SLIM CHICKENS SITE PLAN

PARKER AND PINE FILING NO. 1, LOT 3

SITE PLAN
SLIM CHICKENS
COVER SHEET

1 PHOTOMETRIC PLAN
SCALE: N.T.S.

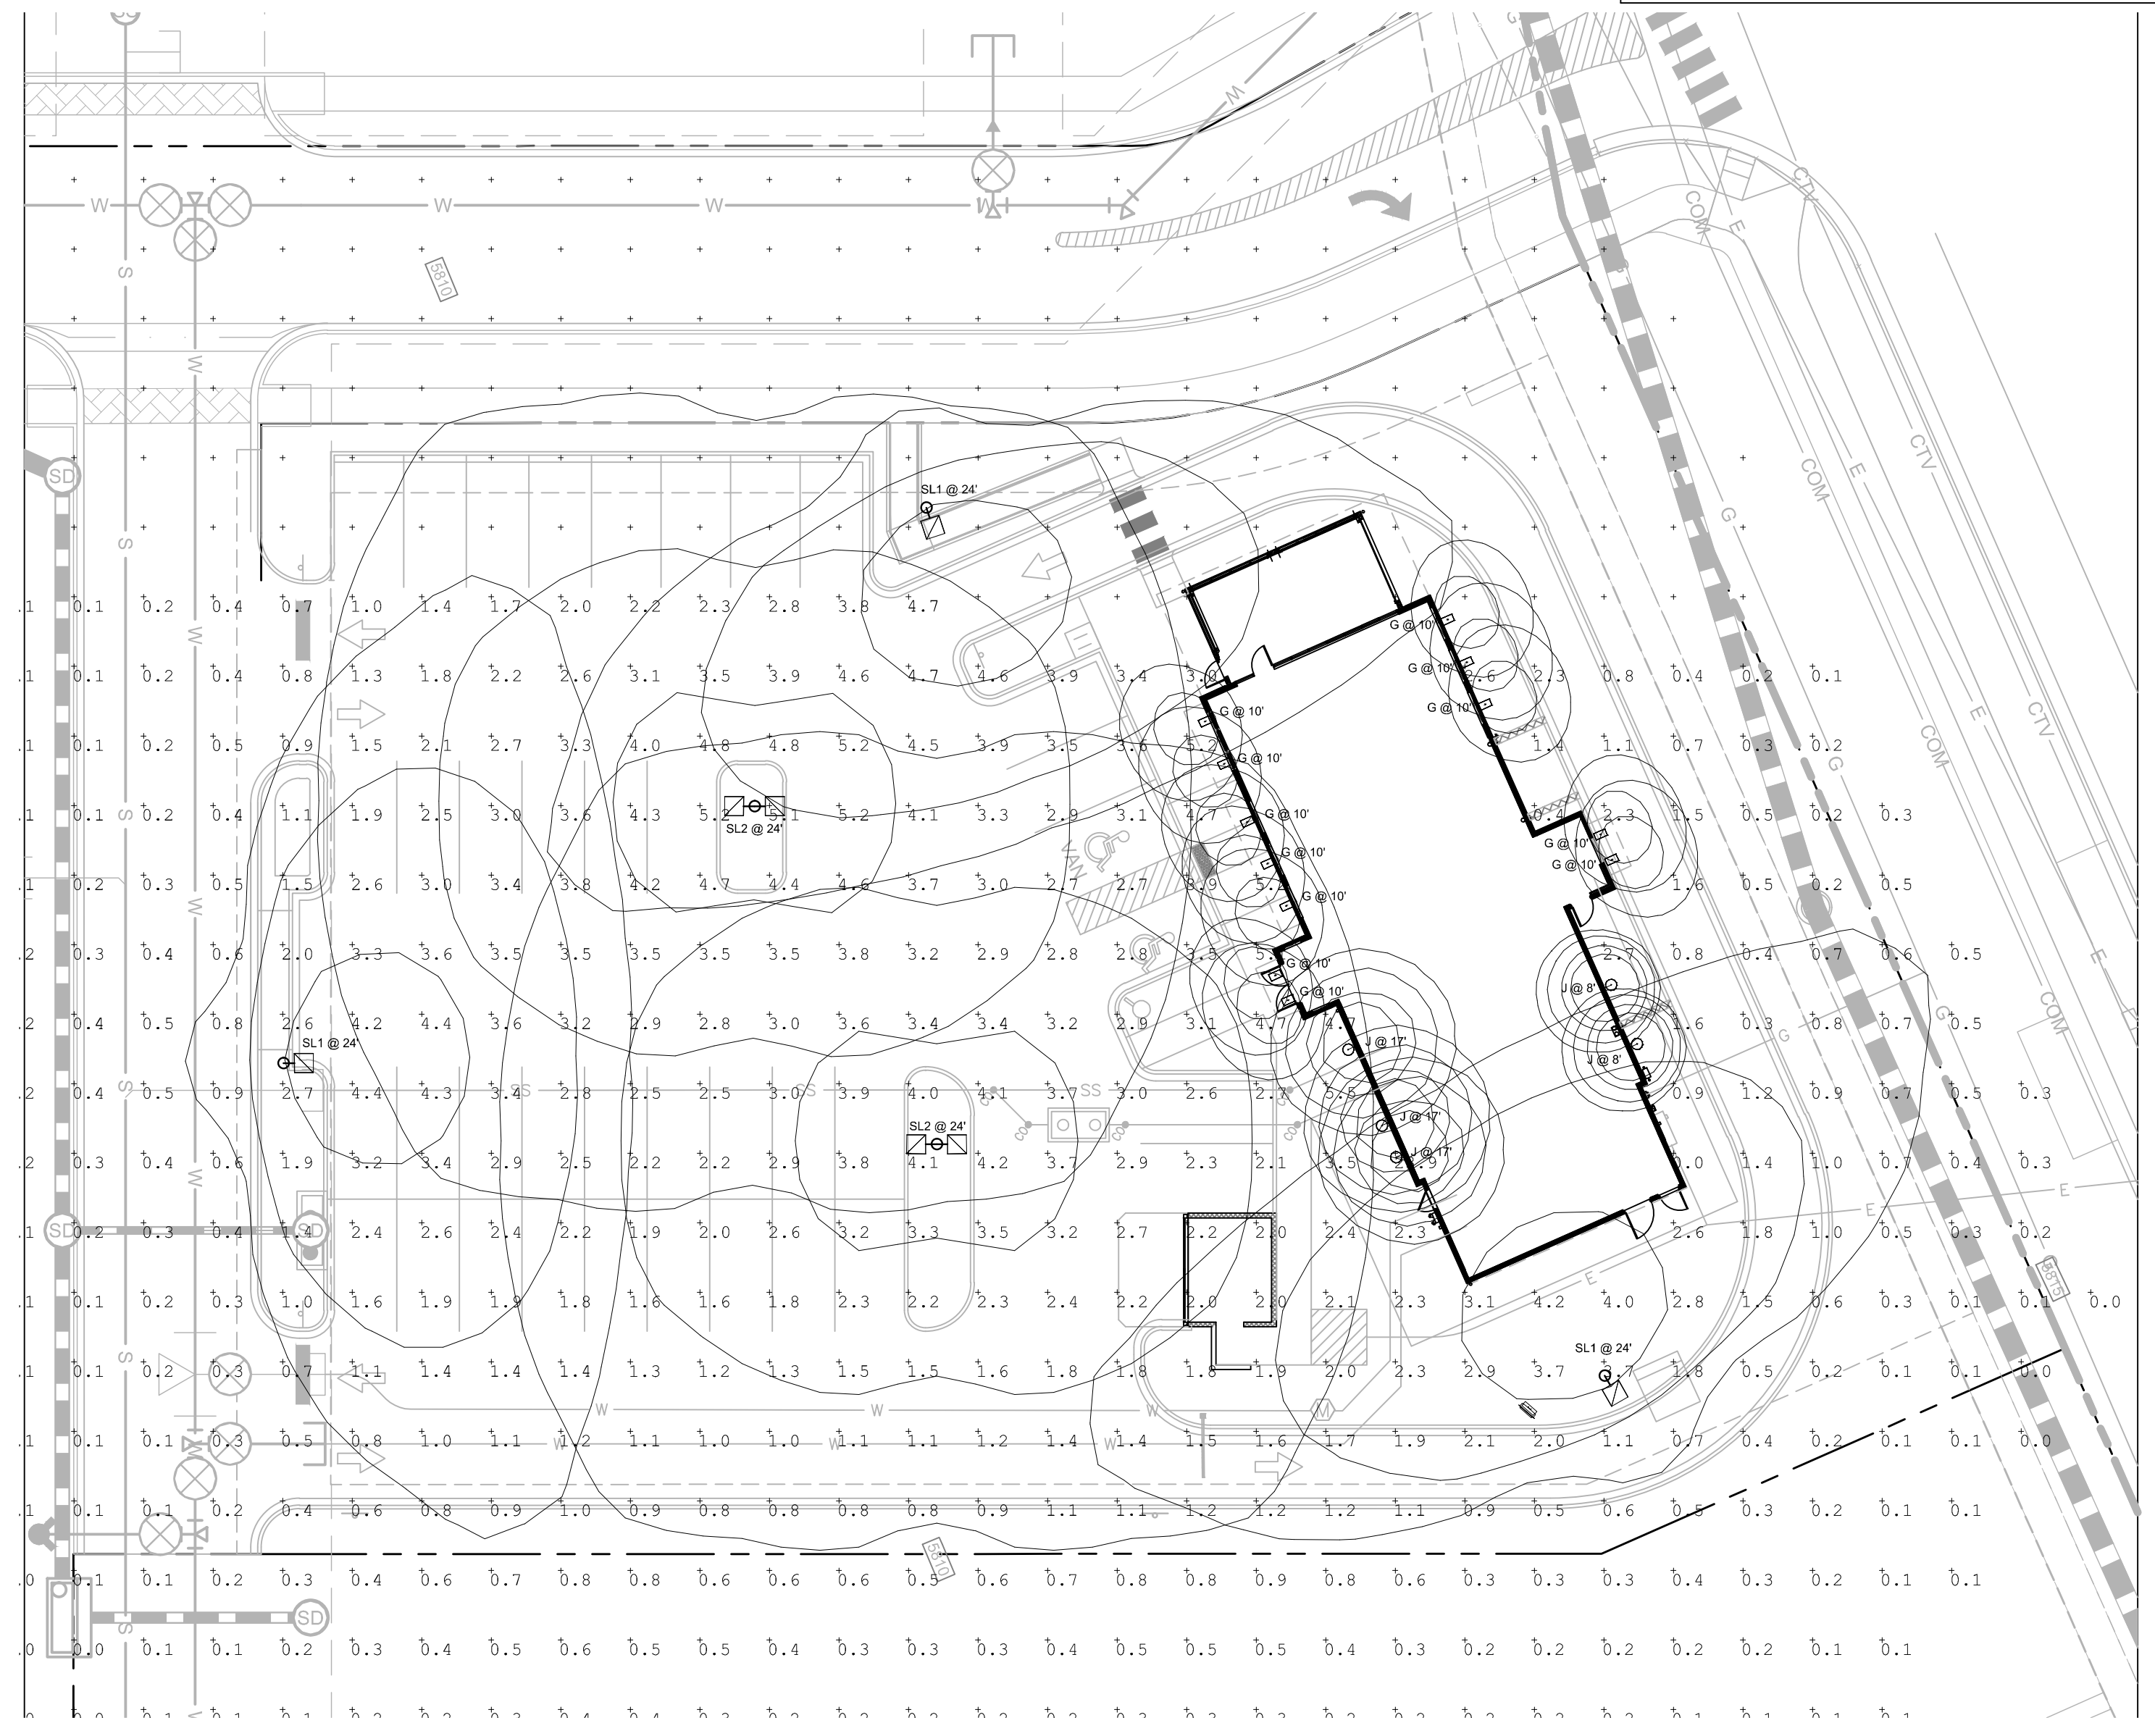
Please add uniformity ratios chart:
a. Per Section 13.10.140 for pedestrian safety and orientation, medium activity lots the maximum Uniformity Ratio (average to minimum) is 3:1.
b. Per Section 13.10.140 for pedestrian safety and orientation, medium activity lots the maximum Uniformity Ratio (maximum to minimum) is 10:1.
